ULPOWER AERO ENGINES N.V.

SERVICE BULLETIN

Service Bulletin No. 2018-03

SUBJECT: Throttle position sensor

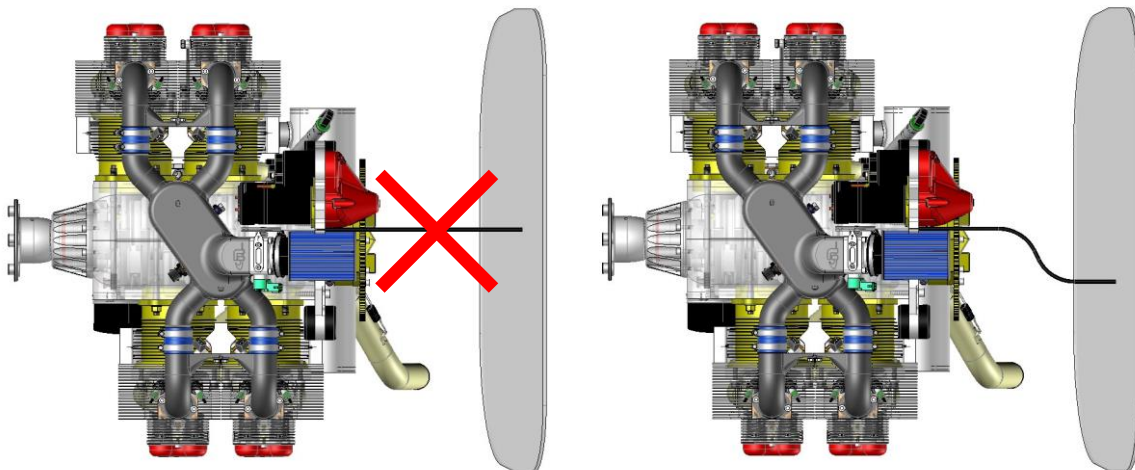
When a throttle cable is installed in a straight line from the throttle lever to the fire wall , or when the lever is controlled by a push/pull (or similar) system, engine vibrations create a non-stop movement of the TPS's brushes on the copper lane, resulting in an early wear of the TPS. This may lead to an incorrect signal to the ECU and a possible engine stoppage in flight.

- 1) Check if your throttle cable is installed in accordance with the official ULPower installation manuals

INCORRECT

CORRECT

If your throttle cable is installed the correct way, no further action is required

If your throttle cable is installed incorrectly, please follow the instructions below

2) Install the throttle cable according to the manuals and replace the throttle body +TPS
